Our Ref: 240085
Council Ref: DA2021/00007

**RE: LOT 12 DP 280089 DA2021/00007
27D RIVERSIDE DRIVE, MAYFIELD WEST – PROPOSED BATTERY STORAGE FACILITY**

Drawing Title
BATTERY MODULE OPTION

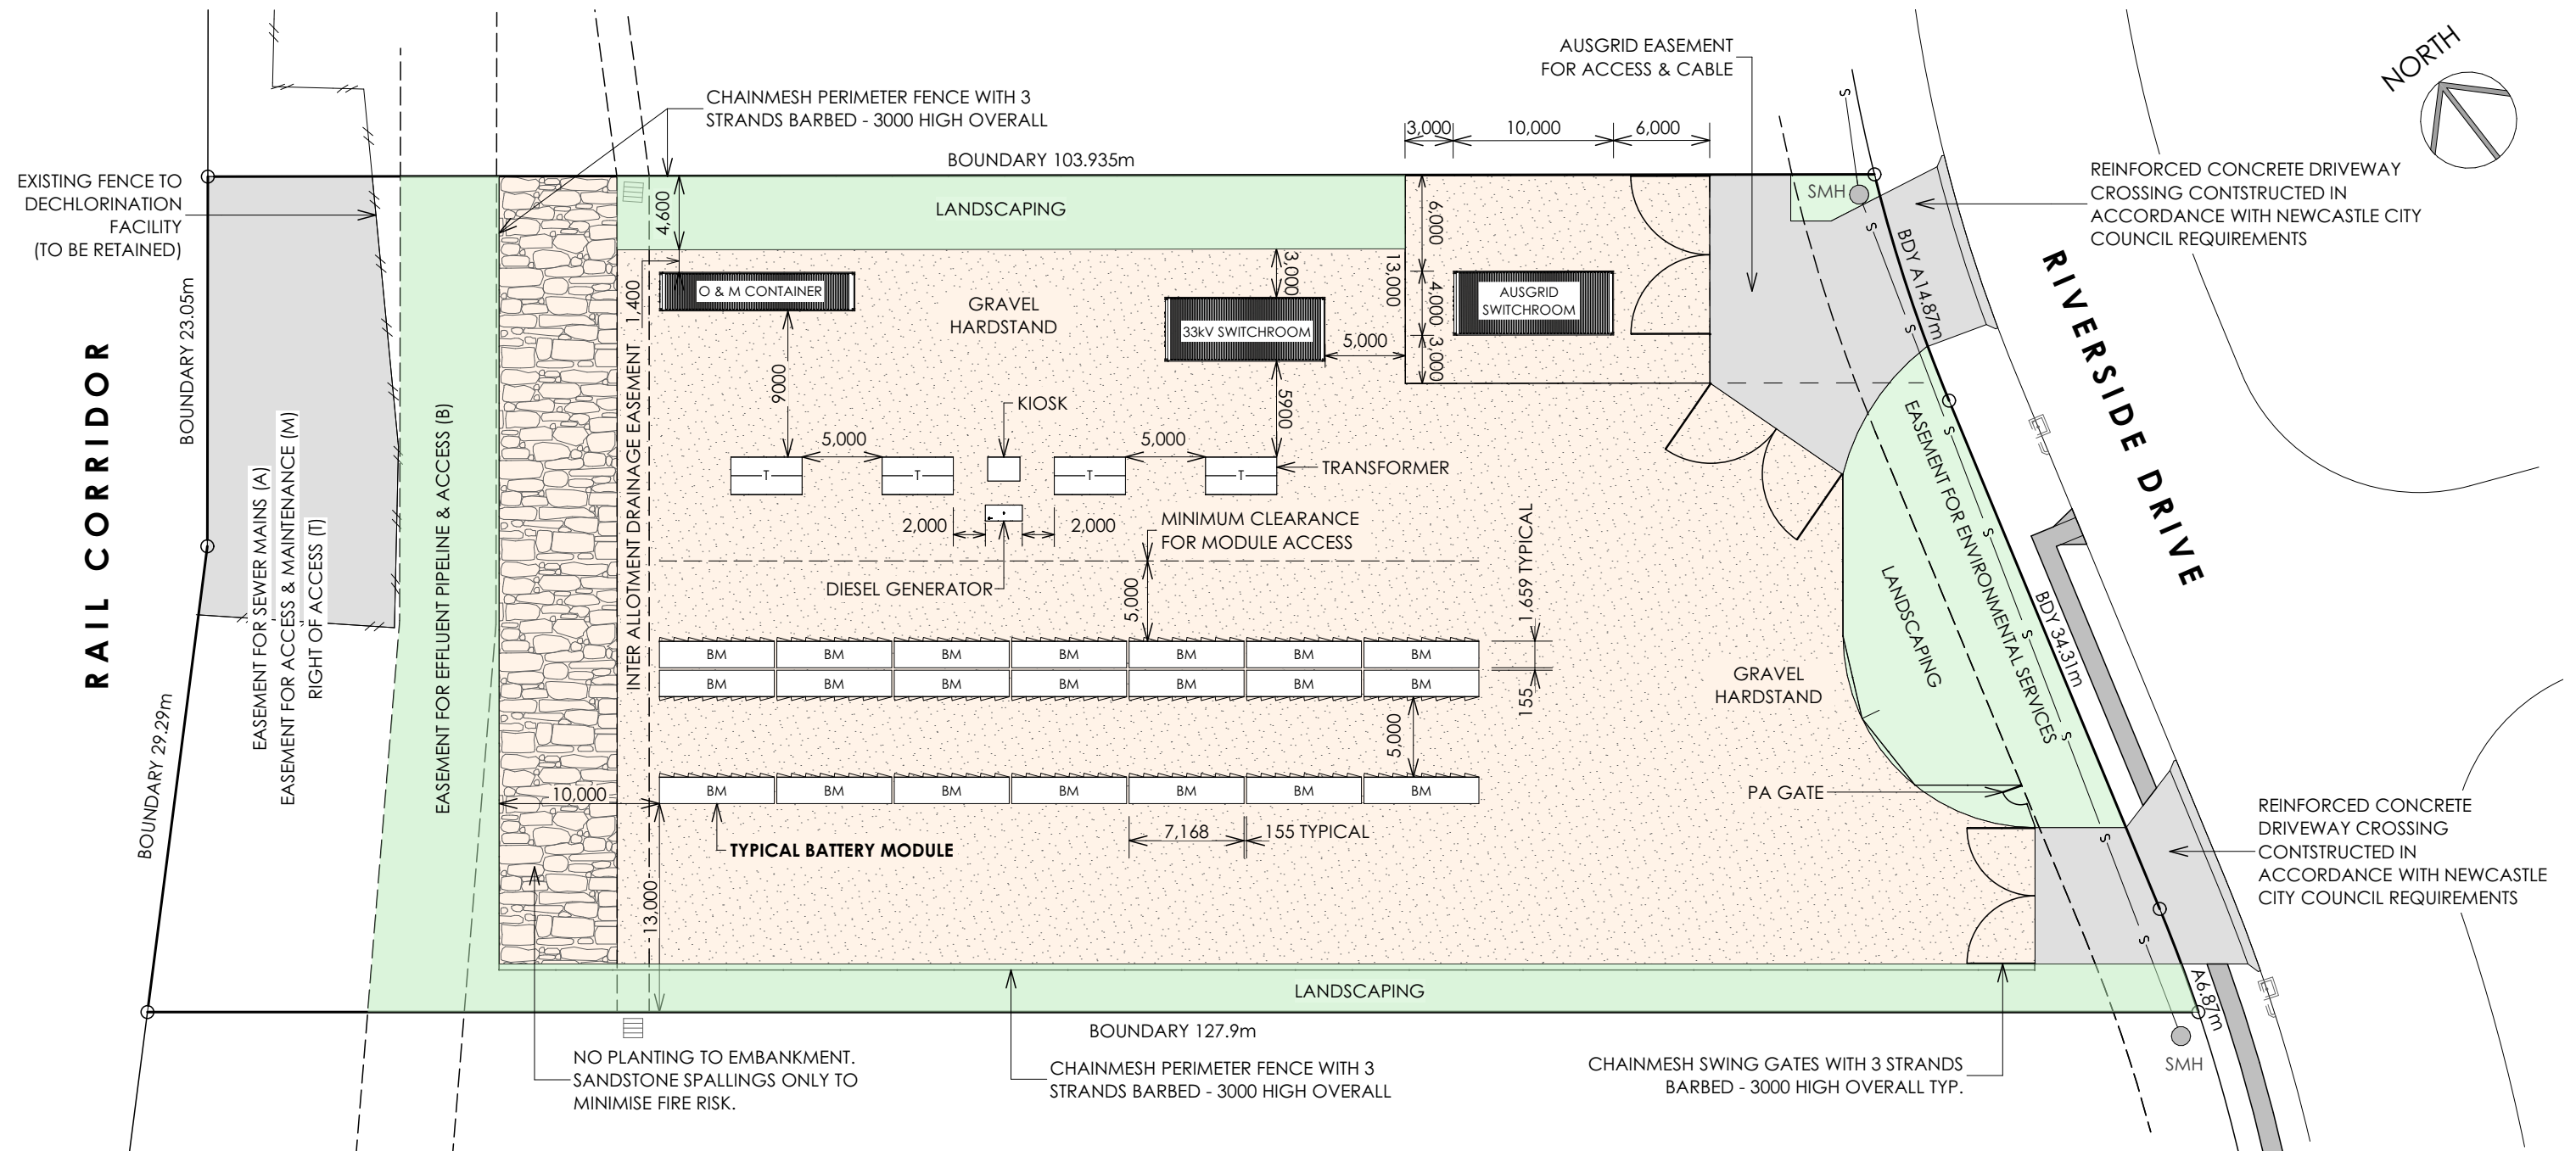
Sufficient details regarding the containerized option have been submitted for the proposal. Conversely, a similar level of analysis was not adopted to analyse separation distance between battery modules (i.e. Tesla Megapacks) and there is insufficient information at this stage to allow support of this option. You would need to confirm if you intend further pursue both battery options as part of the application.

If the 'Tesla Megapack' option is being pursued, further Preliminary Hazard Analysis (PHA) reporting will need to be provided demonstrating the basis on which the risks of this option are acceptable (i.e. which has direct ramifications on the number of batteries and the proposed layout/separations across the site). The extract provided below (as emailed 31 March 2021) from the Department of Planning's hazard assessment may assist addressing these issues.

An updated Preliminary Hazard Analysis (PHA) has been prepared by ARUP for the proposed development and is enclosed as **Appendix E**. The amended PHA gives further consideration to the modular battery configuration. An additional site plan has also been prepared to show the configuration of the Modula Batteries. A copy of this plan is enclosed as **Appendix A**.

An additional site plan has been included within the amended Development Plans provided within **Appendix A**, which details the proposed configuration of the Modular Battery system option. As demonstrated on the plans provided, the Modular Battery configuration can be accommodated within the identified development footprint and will achieve the recommended separation distances as outlined in the PHA.

LANDSCAPE CONCEPT PLAN | L101

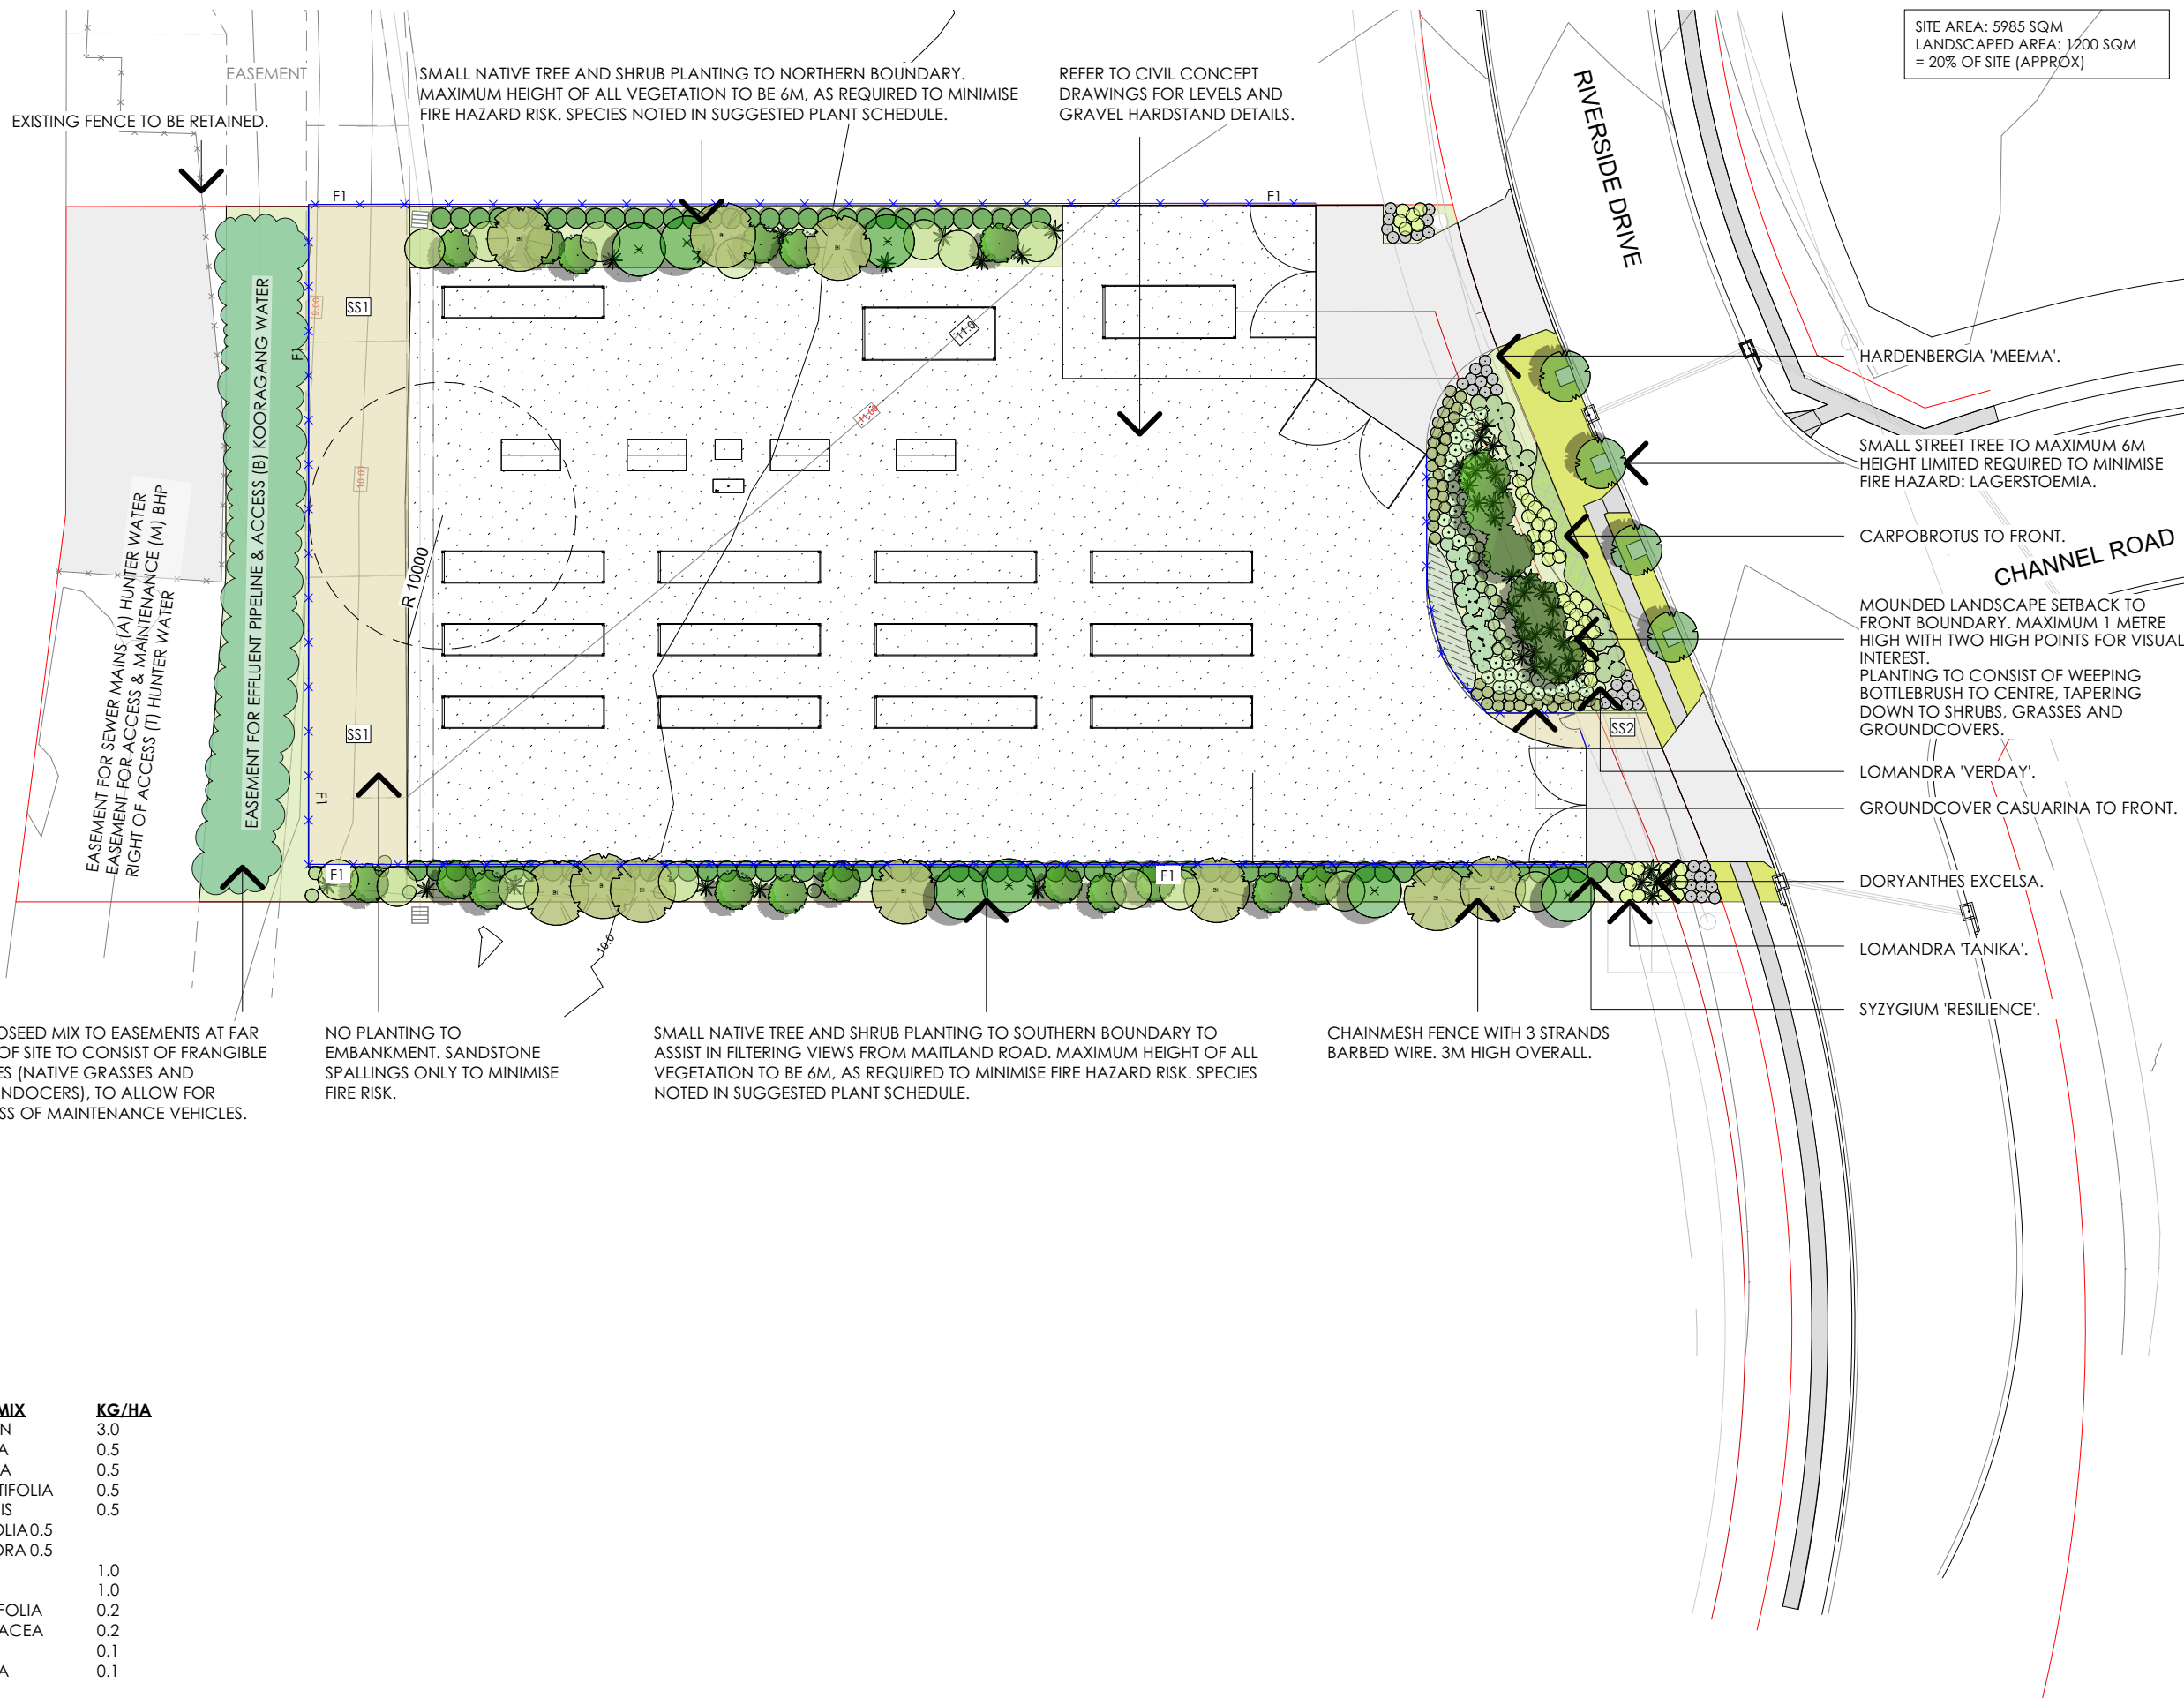
The rear of the proposed lot appears to be in conflict with existing features and easements towards the rear/northern corner. It is necessary to clarify how these features impact the proposal and are resolved. Based on the information available, the submitted plans do not reflect these impacts and show these areas as landscaped and contributing to compliance with the landscaped area percentage (20%) under the SIAS. It is considered that none of these areas would be available for the landscape area where the conflicting features remain and the plans need to be modified to reflect these features/easements and landscape area proposed re-calculated. Additionally, the plans should be amended to include any easements which affect the proposed lot and may have ramifications for how the proposal is assessed.

As requested by Council, an amended landscape design for the proposed development has been prepared by Terras Landscape Architects is enclosed as **Appendix B**. The revised scheme has removed where necessary areas of proposed landscaping which may conflict with the existing easements which extend along the rear of the site.

Figure 11: Acceptable spacing between Tesla Megapacks based on UL9540A testing results. (Note: 5 m separation is based on the analysis performed in this report.)

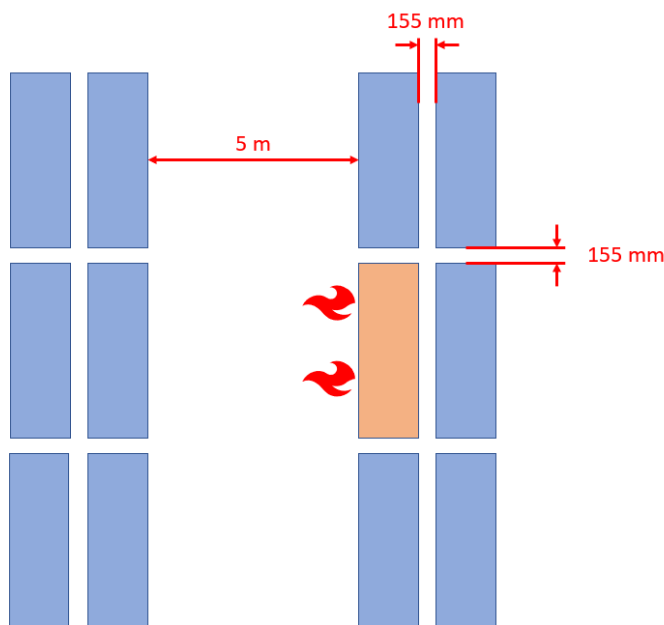
However, a similar level of analysis was not adopted to analyse separation distance between battery modules (i.e. Tesla Megapacks), instead relying on a 2016 US NFPA fire-test on such systems to deduce the separation distances in PHA Section 4.1.1. The Department is aware of significant developments in research and standards for BESS which may run in contrary with 155 mm separation distance in PHA Section 4.1.1. Such research and standards include (not exhaustive):

If specific test data exist, the recommended separation distances between units provided for (from the battery supplier/integrator) can be used in preference to the distances listed here. For example, the Tesla Megapack can be separated by 6 inches (155 mm) side-to-side or back-to-back (i.e. the sides of the unit without doors) as demonstrated by fire testing performed using the UL9504A Test Method, and as shown in Figure 11 in Section 4.1.3. A copy of the Test Report is provided within **Appendix G**.
